# National Transportation Safety Board

## Safety Recommendation

**In reply refer to:** A-00-120

On March 24, 1999, at 1300 central standard time, an Extra Flugzeugbau GmbH EA-300S, N9K, operated by Above & Beyond Aviation, Inc., experienced a separation of the upper left longeron<sup>1</sup> and a diagonal brace tube member at the attach point of the horizontal stabilizer.<sup>2</sup> The separation occurred when the airline transport-rated pilot entered a roll maneuver while practicing for an airshow in Dow, Illinois. The pilot was able to land the airplane without further incident. The pilot was not injured, but the airplane was substantially damaged. The flight was operating under Title 14 *Code of Federal Regulations* (14 CFR) Part 91, in visual meteorological conditions, and without a flight plan.

Figure 1. The attachment assembly for the horizontal stabilizer on the N9K accident airplane.

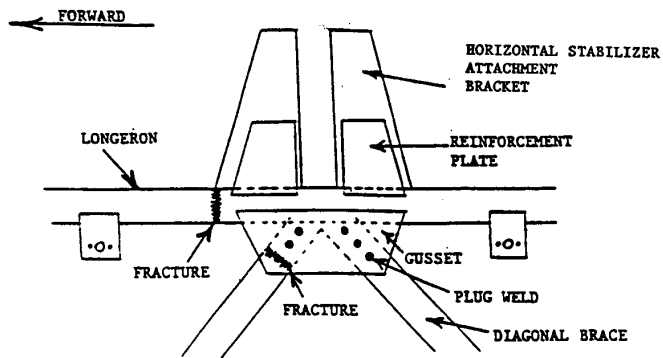
The fuselage construction in the area of the attachment assembly for the horizontal stabilizer on the accident airplane is illustrated in figure 1 (enclosed). The fuselage assembly of airplanes in the Extra 300 series is manufactured from steel tubing. The ends of the tubing are cut at angles then welded to each other to form a frame structure. Four longerons (0.7-inch outside diameter tubing) run the length of the fuselage. An attachment assembly for the horizontal stabilizer is welded to the two upper longerons. This attachment assembly contains one forward and one aft fitting (bracket). On the upper left side of the airplane, two diagonal braces intersect the upper longeron in the vicinity of the attachment brackets for the horizontal stabilizer. The diagonal brace running forward and down from the horizontal stabilizer is called the forward diagonal brace in this letter, and the diagonal brace running aft and down from the attachment assembly for the horizontal stabilizer is called the aft diagonal brace. The brackets and braces on the right side of the airplane are a mirror image to those on the left side.

Metallurgical examination of the separated pieces from N9K was conducted at the Safety Board's materials laboratory. This examination disclosed a fracture through the upper left longeron that intersected a fillet weld located at the forward end of the base of the forward attachment bracket. This fracture contained a fatigue crack that emanated from the toe of the fillet weld. The length of this fatigue crack measured about 0.35 inch circumferentially. A thumbnail-shaped portion of the fatigue crack region contained a blue tint. This blue tint

The operator's weld repair of the upper left longeron was made in accordance with instructions from Extra. However, repair instructions contained in Issues B and C of Extra SB 300-2-95, published later, specifically stated that a sleeve should have been installed on the upper longeron if a crack was found in front of attachment assembly for the horizontal stabilizer. The Safety Board's metallurgical investigation disclosed that the upper left and right longerons of N9K contained no sleeve in the area located forward of the forward bracket for the attachment assembly. The Safety Board concludes that cracking of the upper left longeron probably could have been avoided had the sleeve been installed after Issue B was released.

Issue an airworthiness directive to make compliance with Extra Flugzeugbau Service Bulletin 300-2-95 Issue C mandatory with the exception that the visual inspections be replaced with dye penetrant inspection and that the inspection areas be expanded to include the welds associated with the aft end of the aft brackets for the attachment assembly of the horizontal stabilizer. For any crack detected in the upper longeron area, require operators to weld repair the crack before installing the sleeve described in Issues B and C of the service bulletin. Compliance with this service bulletin should be accomplished on an expedited basis, but no later than the next inspection required by Issue C or annual inspection, whichever is sooner. (A-00-120)

Figure 2. The retrofit parts according to Issue B of Extra Flugzeugbau Service Bulletin SB 300-2-95.

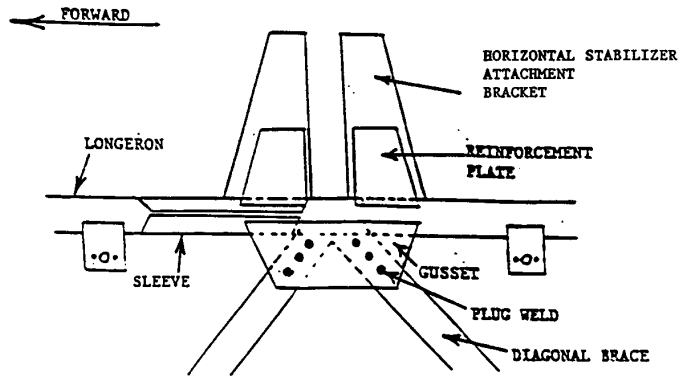
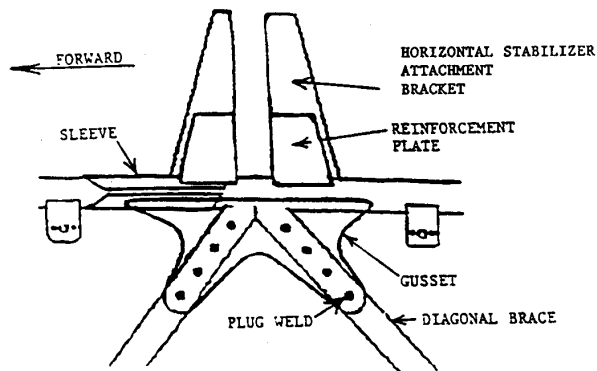
Issue B part II provided repair instructions that would terminate action for the recurring 50-hour inspection specified in Issue A. According to these instructions, the type of repair is determined by the location of cracking. If cracking is found on the forward end of the bracket for the attachment assembly for the horizontal stabilizer, the crack should be covered by a sleeve,<sup>7</sup> and reinforcement plates and a gusset also should be installed in the area of the attachment assembly for the horizontal stabilizer. Alternatively, if cracking is found in the general vicinity between the brackets for the attachment assembly, reinforcement plates and a gusset should be installed in the area of the bracket assembly. Figure 2 illustrates the retrofit parts that should be installed on the fuselage according to Issue B of the SB.

Issue C of SB 300-2-95, released on July 15, 1998, contained several changes regarding the retrofit parts that should be installed on the fuselage (see figure 3). The gusset described in Issue C is made from a plate that contains two legs with rounded edges, whereas the gusset described in Issues A and B is made from a plate with straight edges. The Issue C gusset is also slightly larger than the Issue B gusset, and it has four plug welds<sup>9</sup> on each diagonal brace instead of the three plug welds for the Issue B gusset. A representative from Extra Flugzeugbau indicated that the Issue C gusset allows for better distribution of stiffness in the reinforcement area.

The gusset in Issue B is slightly smaller than the gusset in Issue C, and it contains fewer plug welds than the gusset in Issue C. Issue B gussets may have been installed in the fuselage of EA 300 series airplanes, and this gusset may not have been replaced with an Issue C gusset. The Safety Board believes that the round edges and larger size of the Issue C gusset will provide better stress distribution at the attachment area of the horizontal stabilizer. The Safety Board is concerned that the Issue B gusset may not adequately reinforce the attachment area and, as indicated earlier in this letter, believes the FAA should mandate the installation of Issue C gusset on EA-300 series airplanes.
